# THE MARINE WORKS (ENVIRONMENTAL IMPACT ASSESSMENT) REGULATIONS 2007 (AS AMENDED) MARINE LICENCE APPLICATION CML2365 – HYNET CARBON DIOXIDE TRANSPORTATION AND STORAGE PROJECT – OFFSHORE

**Applicant response to Request for Further Clarification dated 11 October 2024.**

Figure 24.1: Nearshore marine operations cable lay vessel in Welsh Channel (Step 1 of 6)

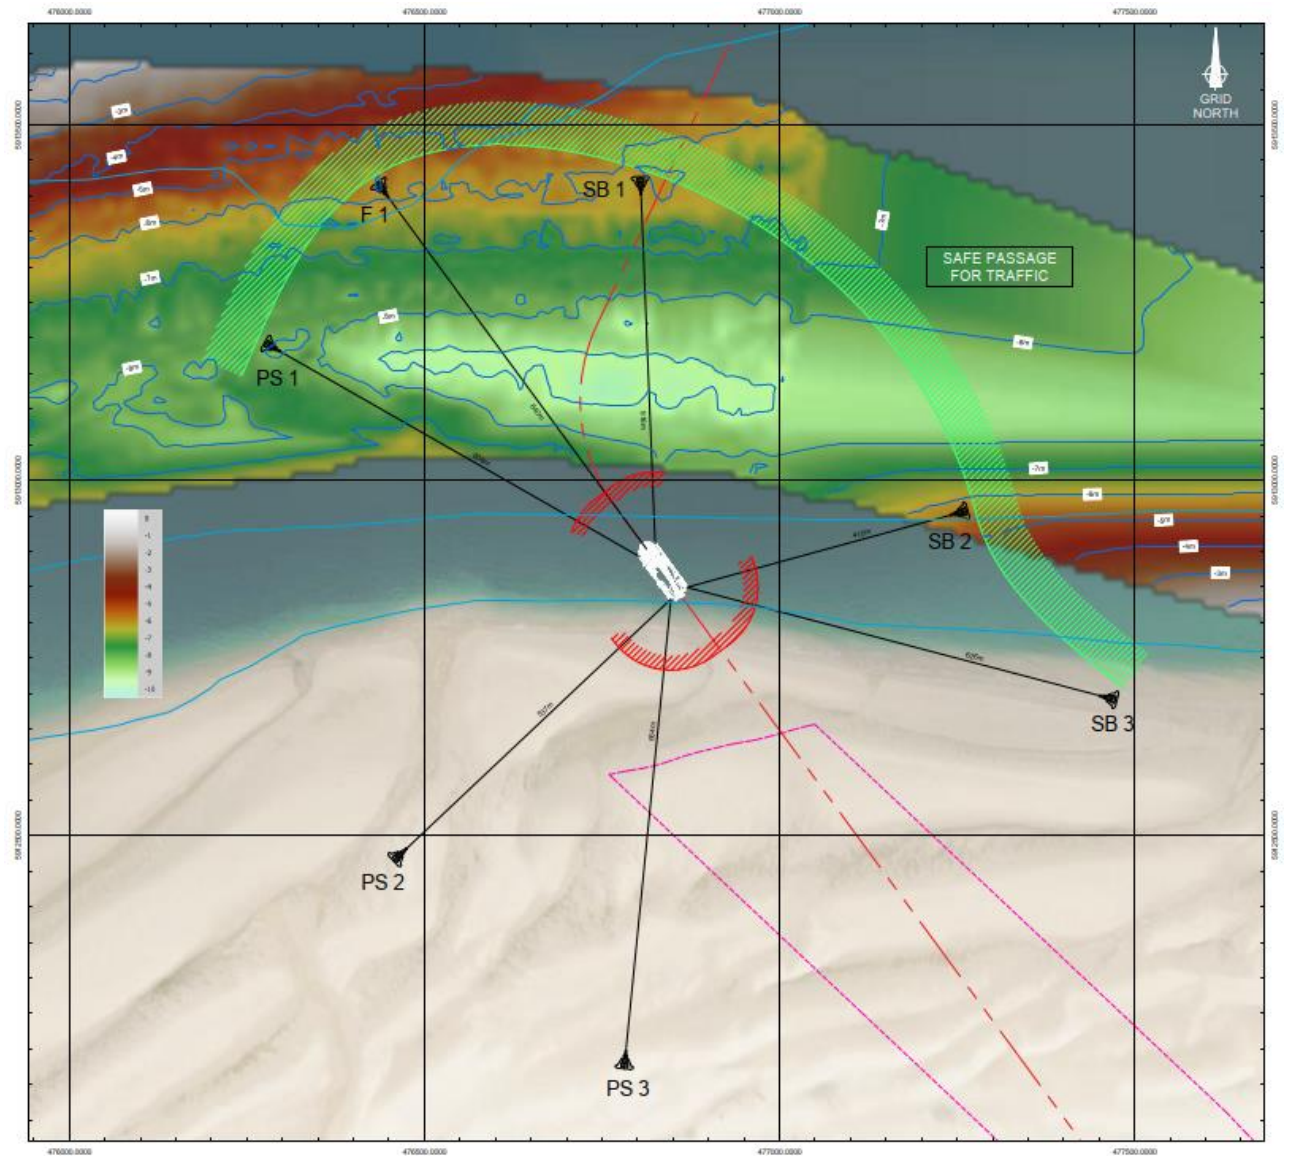
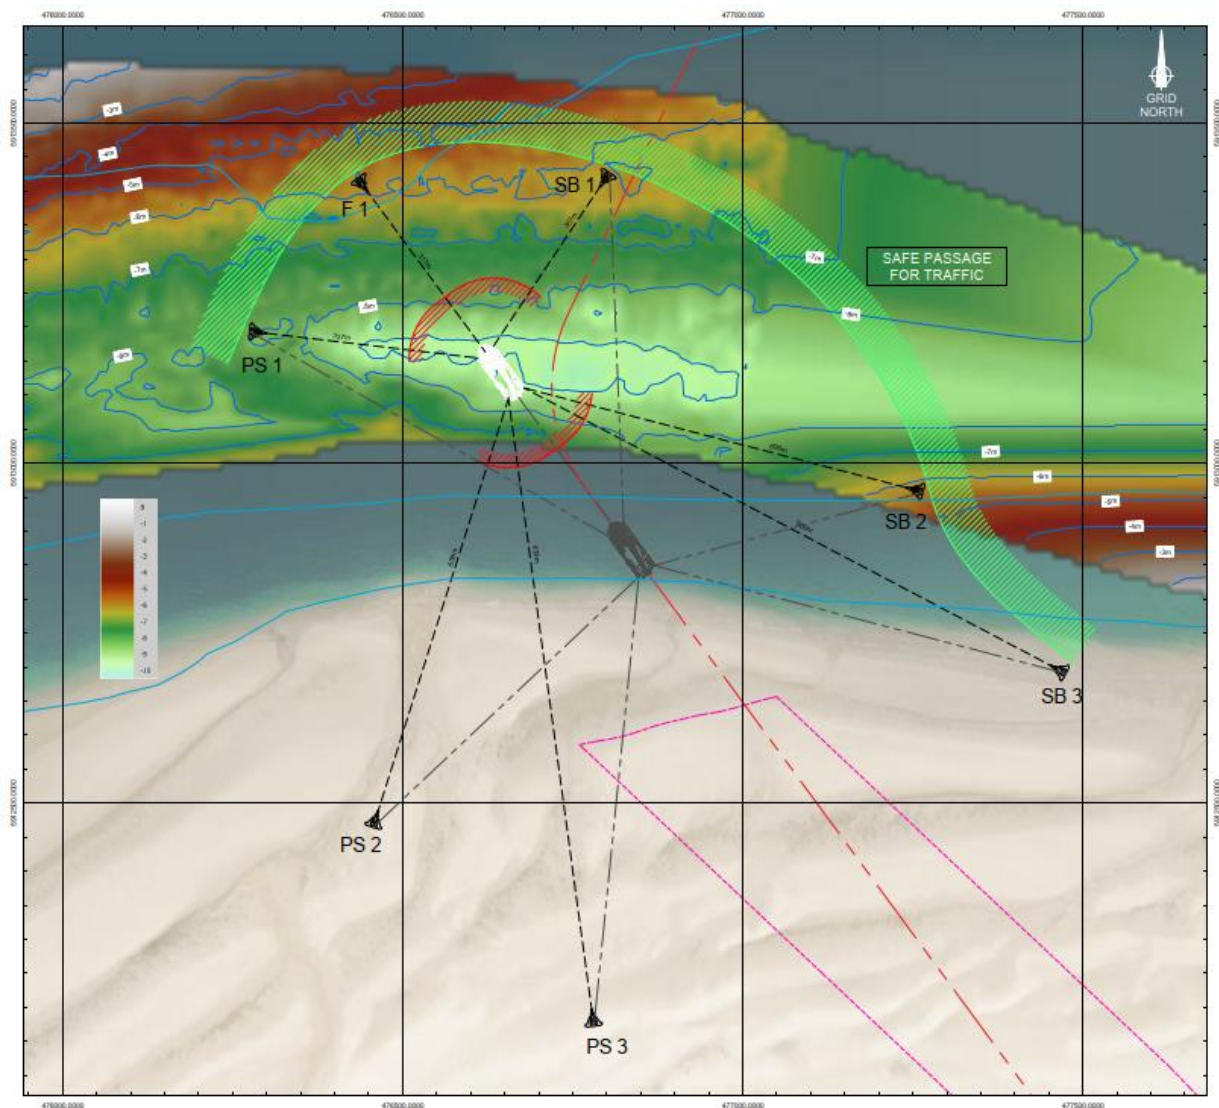
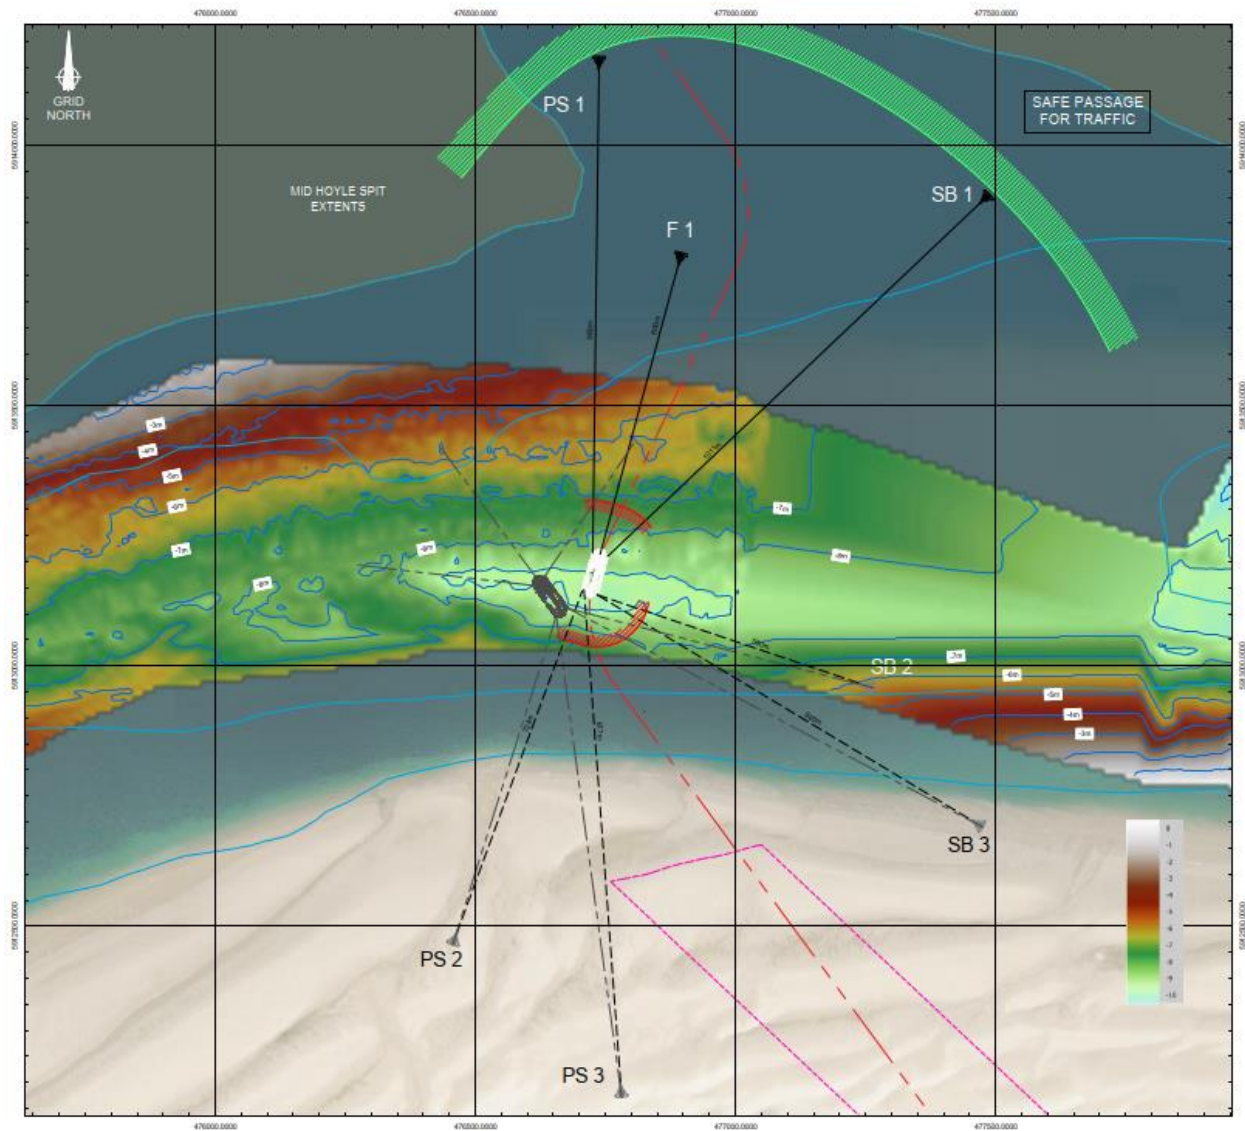
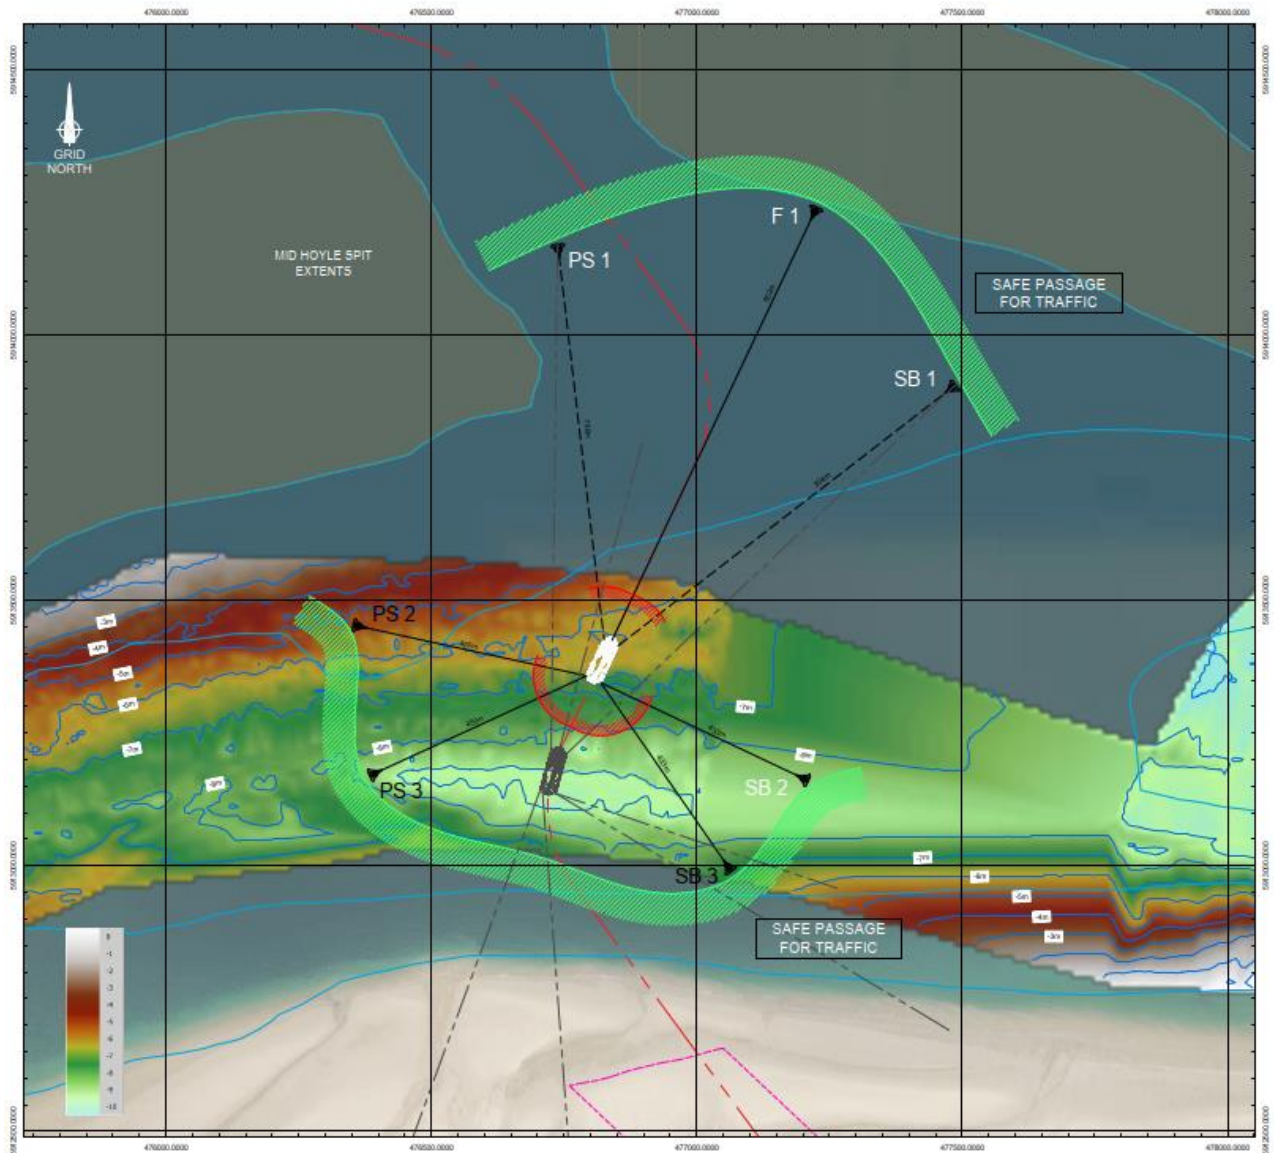
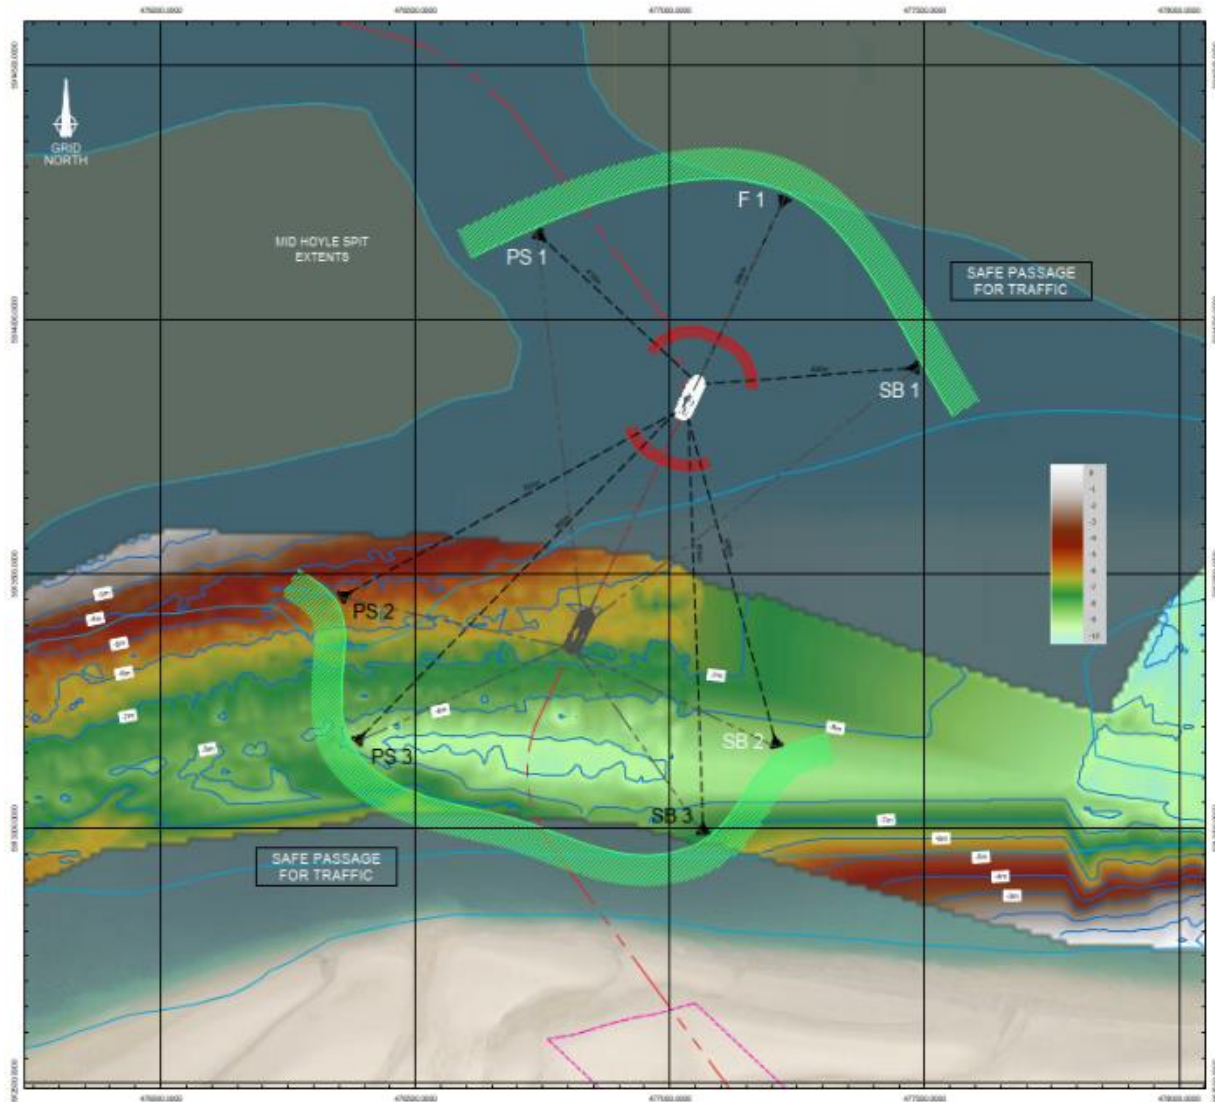
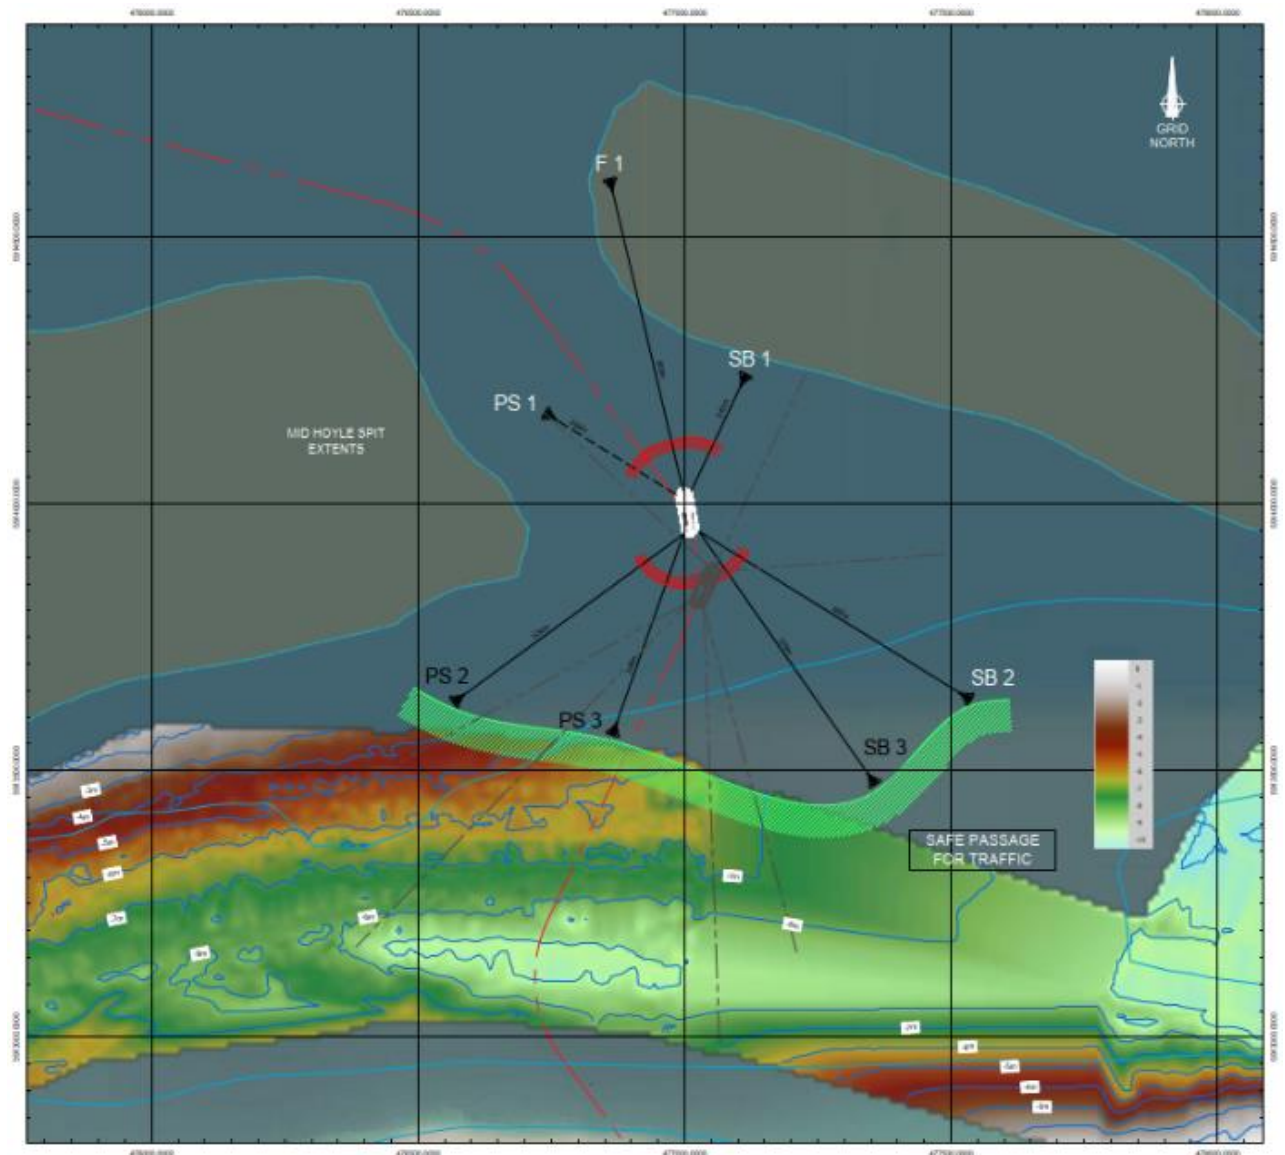
**Action required:** Please confirm receipt of the survey data. Please confirm whether the cable can be buried to the depth of the existing pipeline and allow for the planned maintenance dredging of the outer Welsh Channel?

**Action required:** Please provide clarity on the effective timings for closure of the Welsh Channel. Please let us know if any agreements have been reached with the Port of Mostyn.

The Applicant confirms the receipt of survey data and its incorporation into our vessel management planning. **Figure 24.1 to Figure 24.6** show the passage and manoeuvring of our CLV during our proposed nearshore cable marine operations. These drawings will inform our ongoing conversations with the Port of Mostyn (PoM). The drawings show that it should be possible to provide a 'safe passage for traffic' to both the north and south of our CLV where it crosses the Welsh Channel.

**Figures 24.1 to 24.6** show the cable installation operation and anchor pattern for the Cable Lay Vessel (CLV) during lowest astronomical tide (LAT). Above each drawing is a table giving the approximate duration of that step of the simultaneous cable lay and burial operation. The figures and tables show that once the CLV leaves its beached location it will take approximately 20 hours to transit the Welsh Channel. The figures show that there will always be a safe passage for traffic to either the bow or the stern of the CLV.

Figure 24.7: Observed foraging range of Little Terns associated with Gronant Dunes and Talacre Warren SSSI

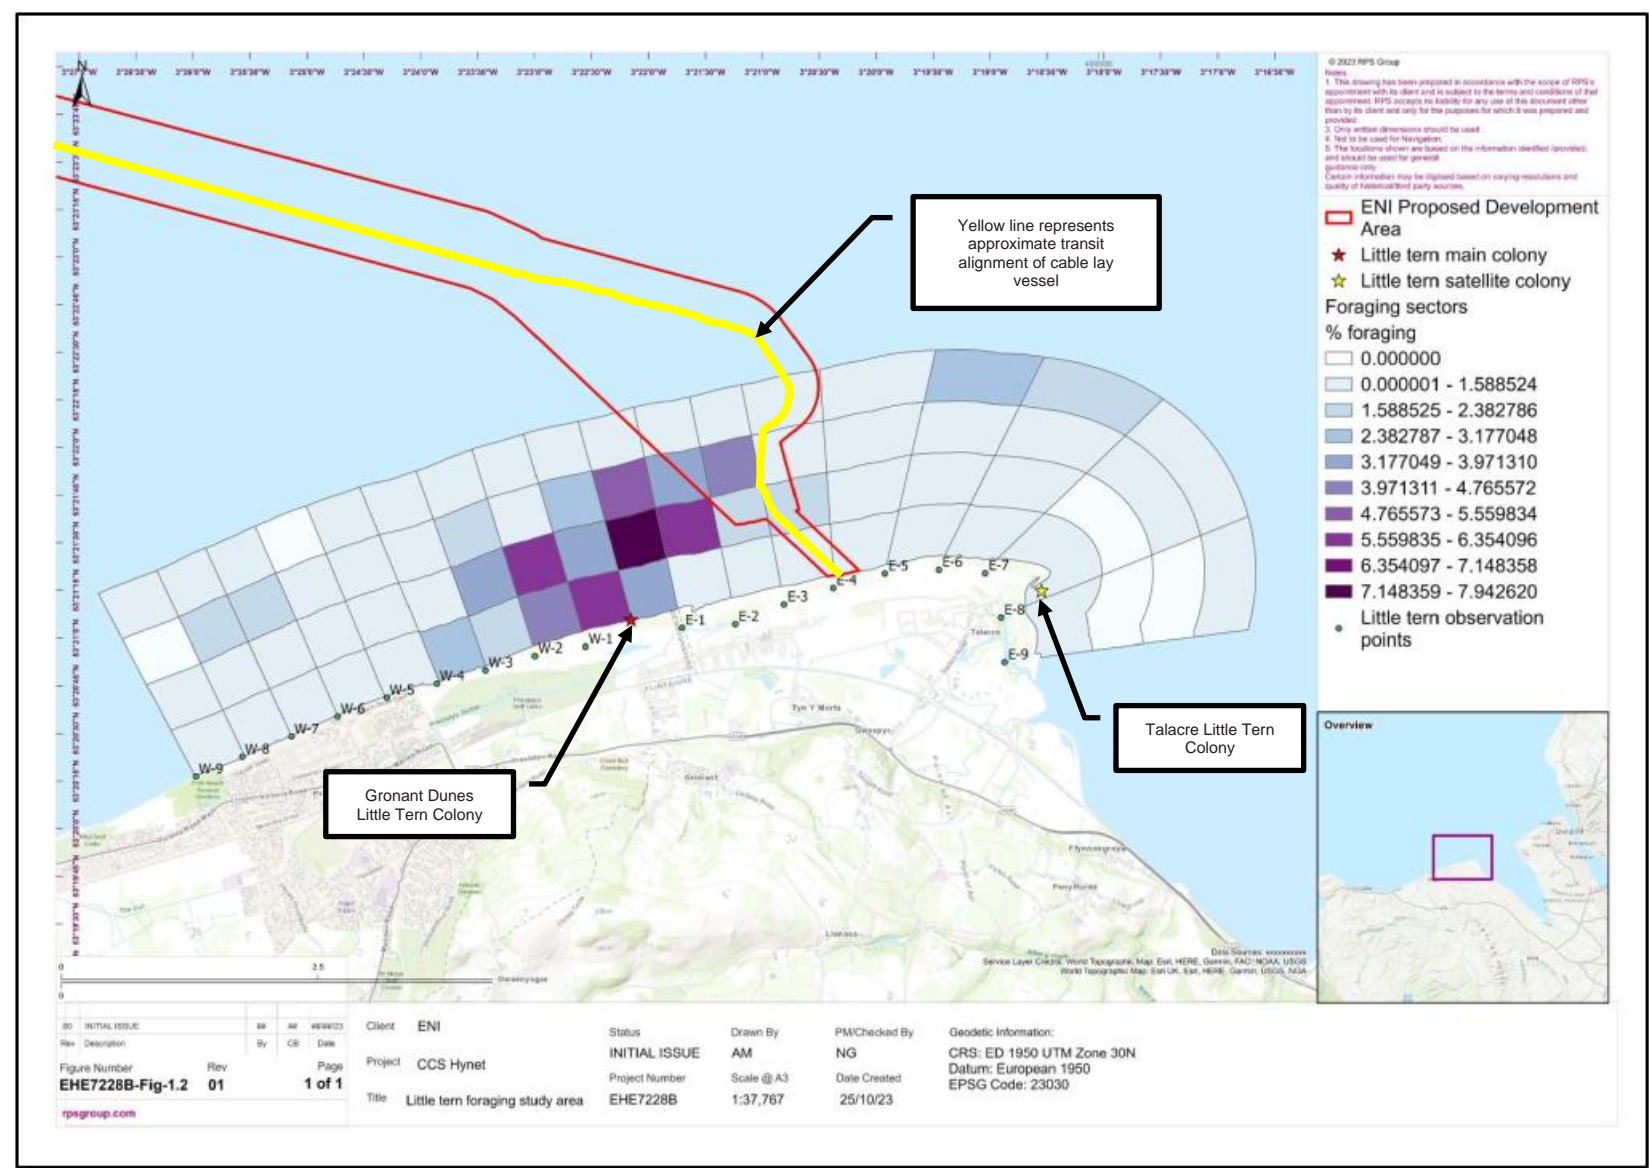
**Action required:** Please clarify timing restrictions and confirm the plans in which these timing restrictions are proposed to be secured.

In terms of the key prey items for bird interest features of the SPAs. Terns mainly feed on fish, but also shrimps and other crustaceans, small squid and marine worms. The ability of these species to catch prey items is not considered to be impaired given the scale of their foraging ranges, as shown in **Figure 1.3** in the Offshore ES Volume 3, Appendix K4: Little Tern Foraging Technical Report, reproduced below as **Figure 24.7**.
